Friday 22 May, 2015

Mr Brian Gilligan  
Chair  
Planning Assessment Commission  
GPO Box 3415  
Sydney NSW 2001

**Submission as an objection to proposal R031/15  
- Springvale Mine Extension Project**

*Proposed pipeline and road route through a gully with an endangered ecological community that lies between as Clerestory Spurs 7 and 8*

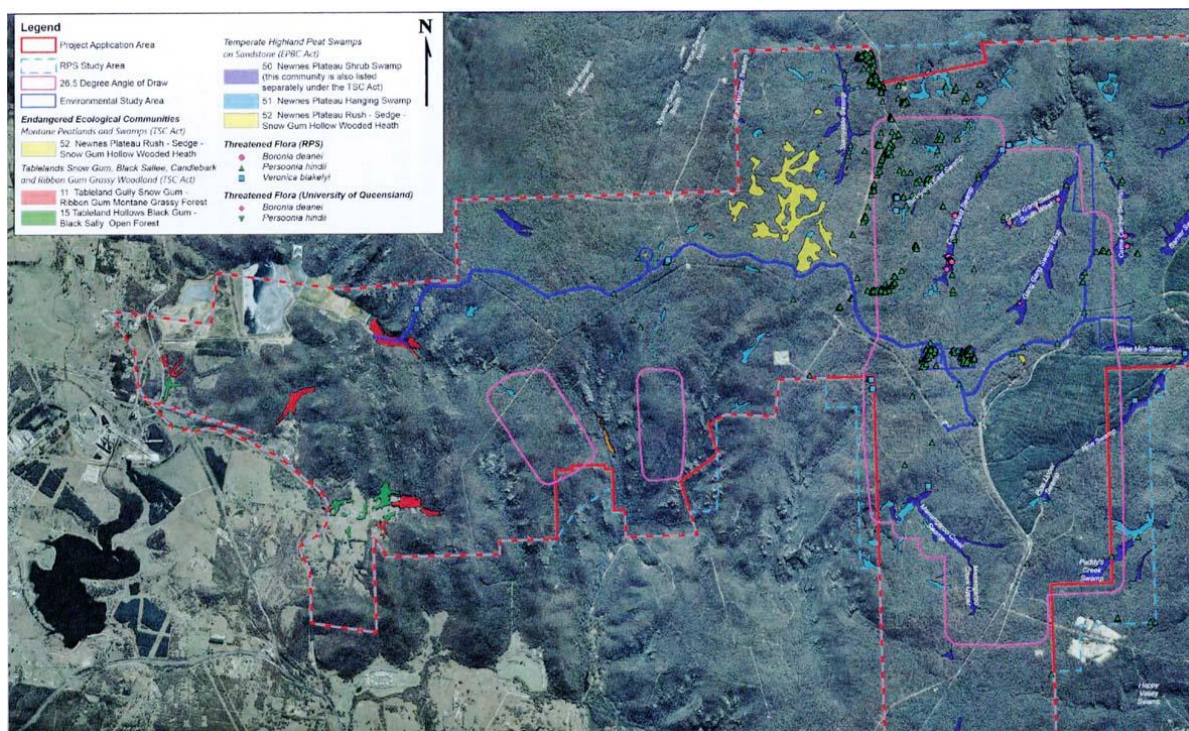
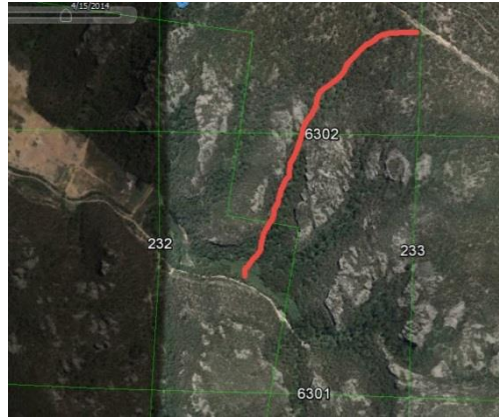
amended. Nevertheless, any proposed pipeline should be required to follow the existing SDWTS pipeline alignment to prevent unnecessary damage into this scenic and ecologically important part of the Gardens of Stone region.

Existing transfer pipeline enters Sawyers Swamp Creek valley from the west (figure above), the proposed pipeline would enter this valley from the north causing unnecessary environmental disturbance (figure below).

*The figure and inset images above indicate the arrangement of Angus Place underground storage and a very green, iron stained swamp that lies above it. Swamps that receive mine effluent, such as those at the Baal Bone Colliery have a similar appearance.*

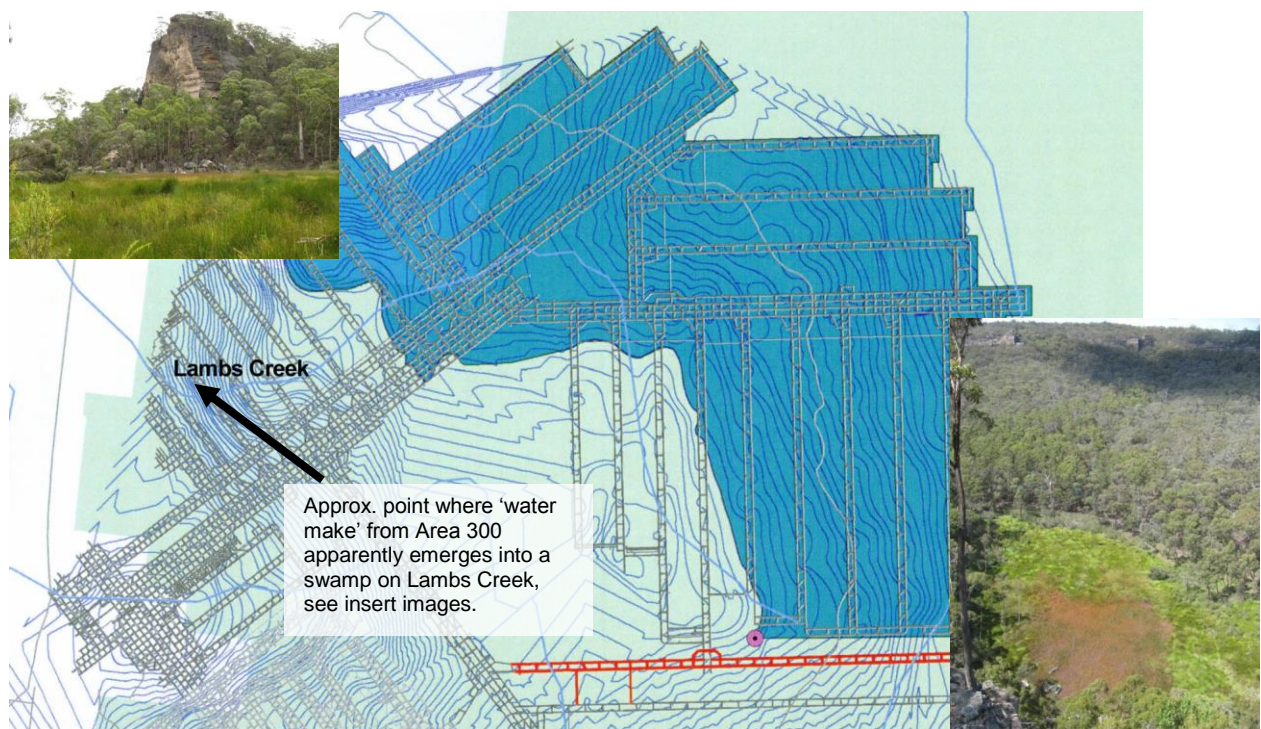
proposal if that mine is to remain in either a production or a care and maintenance state. Currently it is claimed that 5ML/day is directed to an underground storage in Angus Place mine. This arrangement cannot continue for long, unless the storage reports to the surface.

Angus Place Mine denies that it is possible for mine water to emerge at Lambs Creek as the storage is about 100 metres below the surface. The Colong Foundation retains doubts about this underground storage and Lambs Creek, but has no proof of re-emergent water. The large unnatural 'spring' on Lambs Creek at the point indicated remains a mystery...

**Figure 5 Burralow Formation Isopach**  
(Note: shrub swamps shown with black outline)

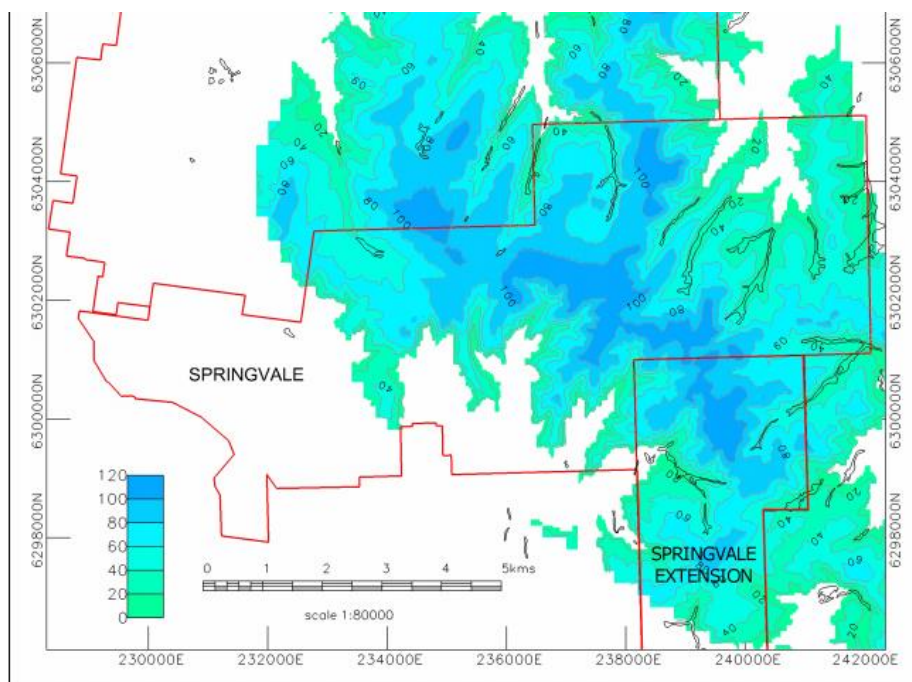
The extent of the Burralow formation is shown in Figure 5 below, which indicates that the damage to Kangaroo Creek, Junction, Narrow and East Wolgan Swamps all overlie overlie this formation (see McHugh, Appendix 18, Part 1, page 13). As this Formation covers the proposed mine extension area, then past damage can be taken as a reasonable indicator of future swamp damage.

The aquitards lie directly under the swamps as clearly indicated in the figures provided in the evidence by Elizabeth McHugh (Response to Submissions Appendix 18 the Geology of Shrub Swamps within the Mine Extension Areas, Sept. 2014). The cracking associated with this formation is alleged by the proponent's consultants to be from 10 to 15 metres in depth (Environment Assessment, Appendix E, Groundwater Impact Assessment, Figure 40, April 2014). This surface rock fracturing associated with longwall mining has in the past and will in the future pass through the first few aquitards of the Burralow Formation.
